Revisions:	Date:
ADDENDUM 1	08-09-24

GENERAL STRUCTURAL DETAILS

DESIGN REPLACE BOILER PLANT

438-22-900

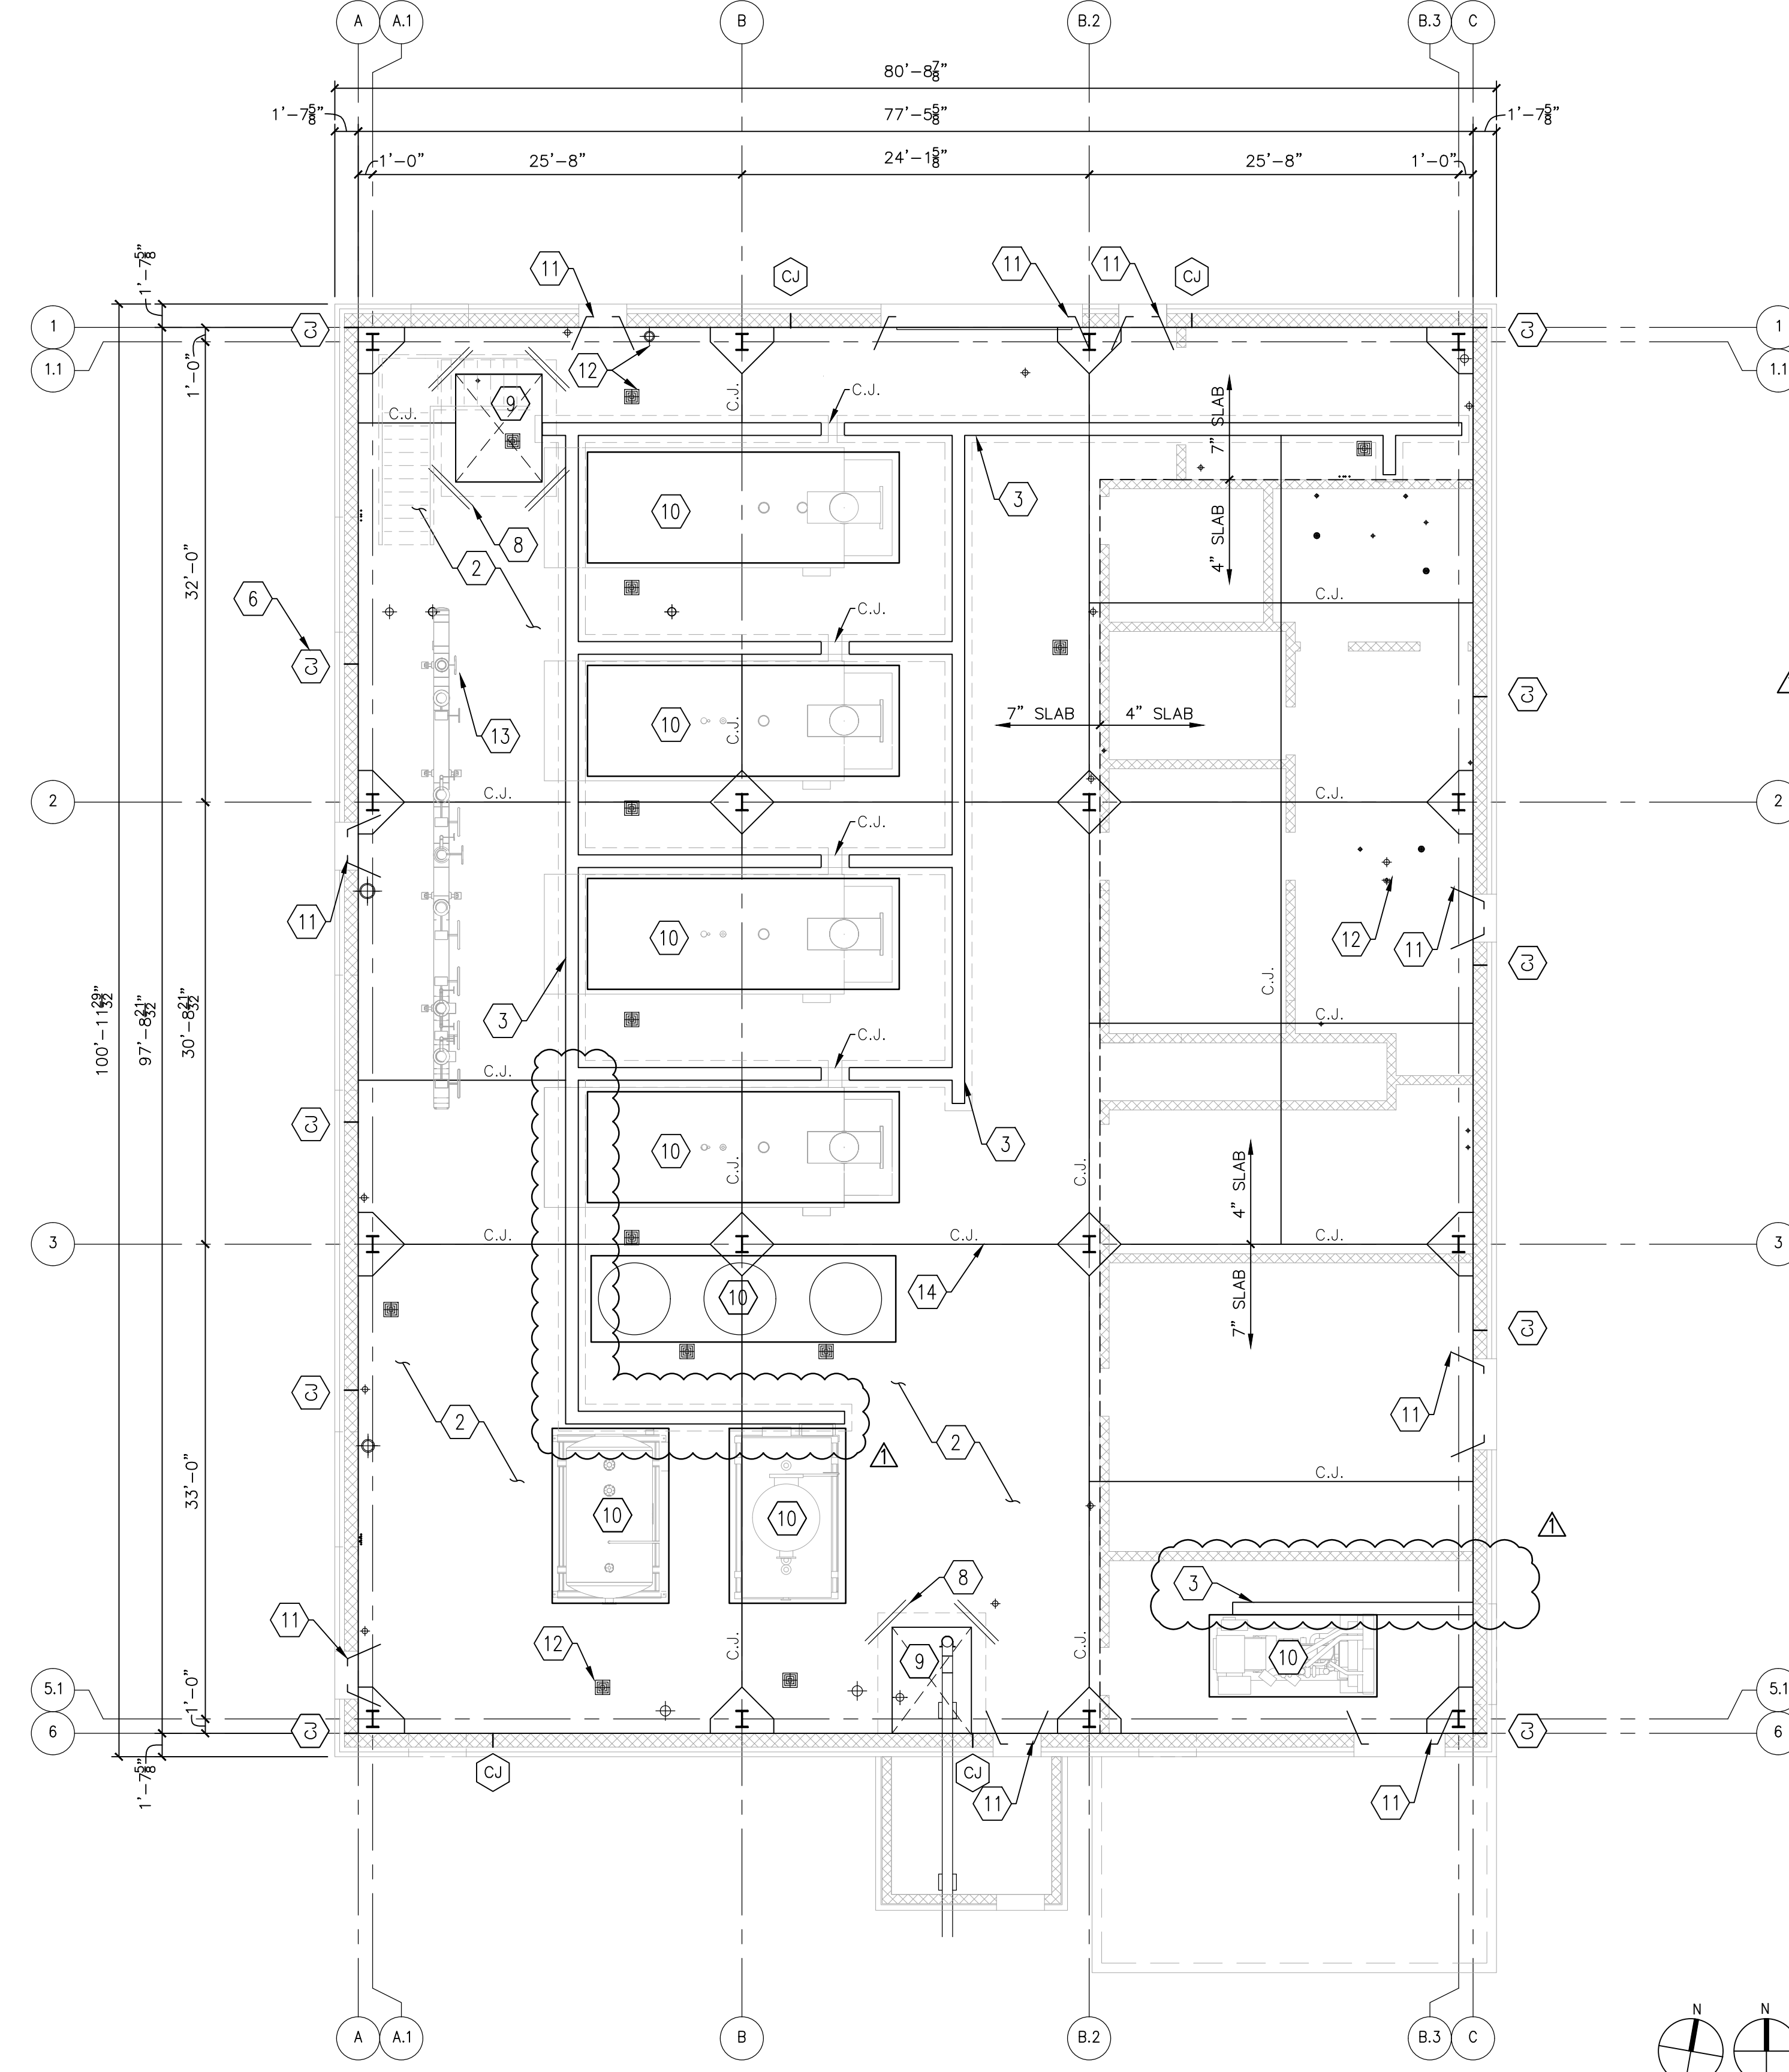
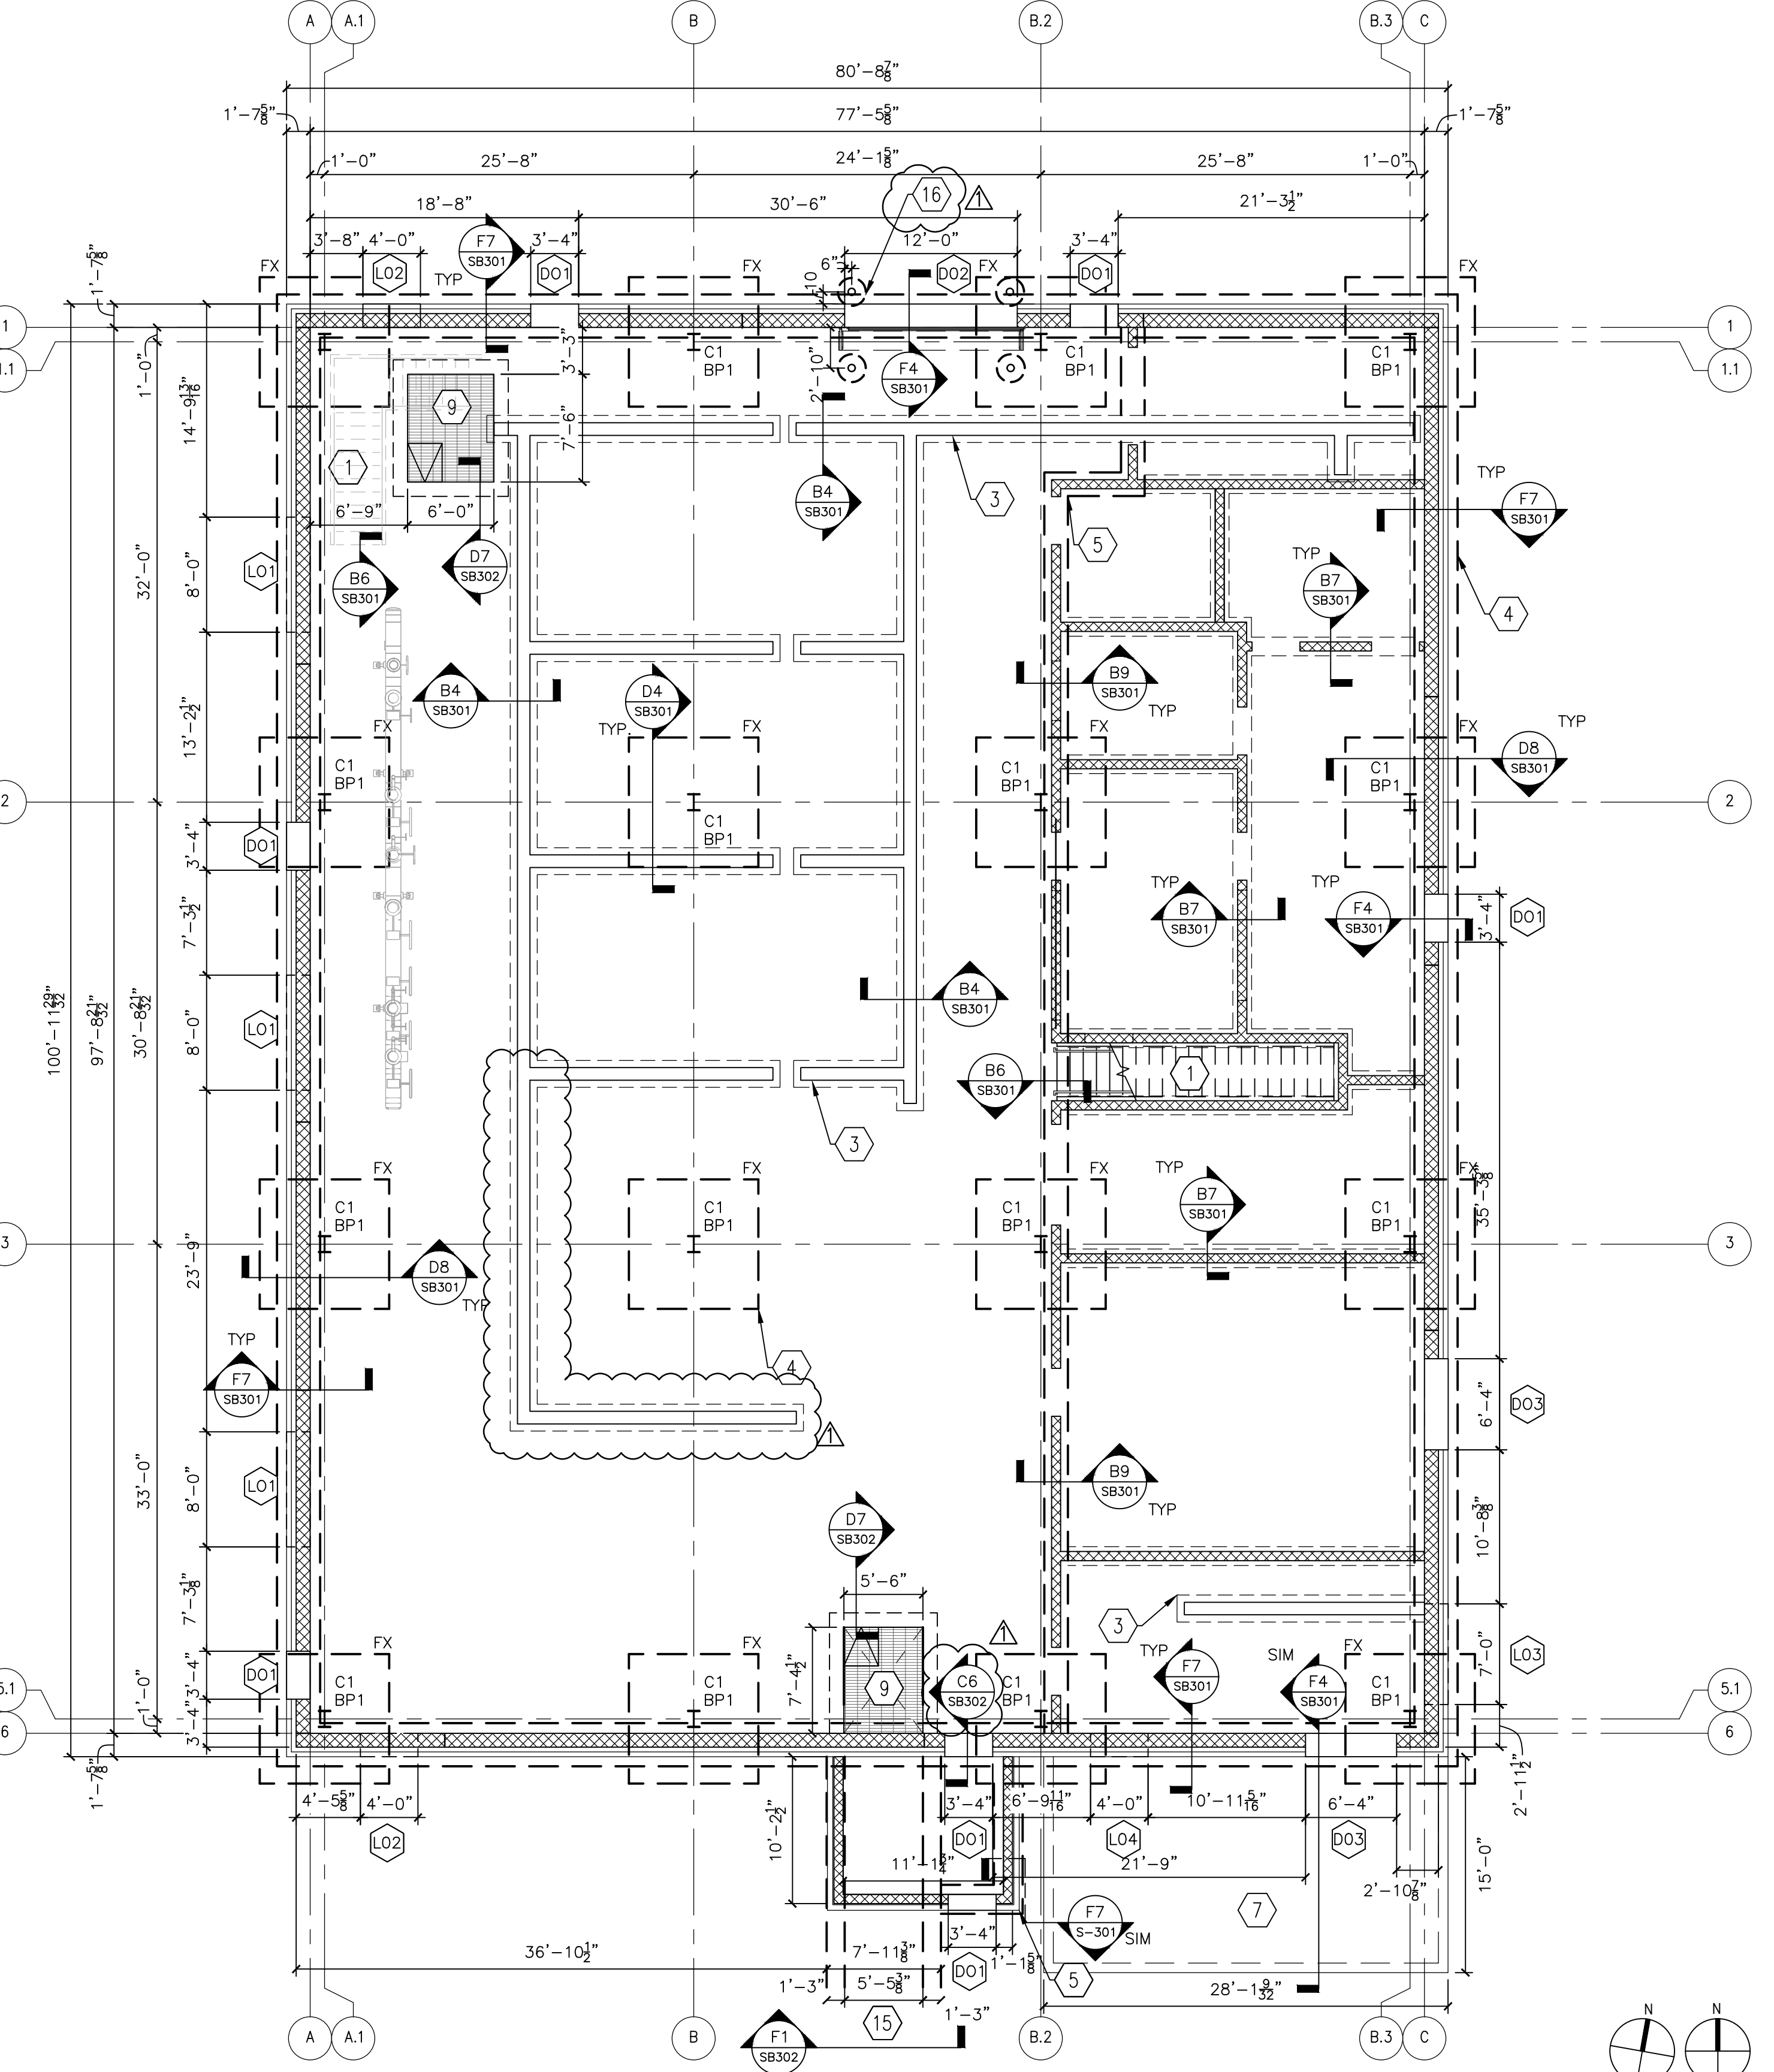
- STEAM TUNNEL, SEE MECHANICAL AND CIVIL FOR EXTENTS. SEE SB302 FOR DETAILS.
 - SEE F7/SB302 FOR BOLLARD INSTALLATION DETAILS, TYP.
- GENERAL ADD1 NOTES:
 ADDED TYP WHERE APPLICABLE TO NOTES AND DETAIL FOR CLARITY.
 ADDED KEYNOTE CALL-OUTS TO TYP. ITEMS FOR CLARITY
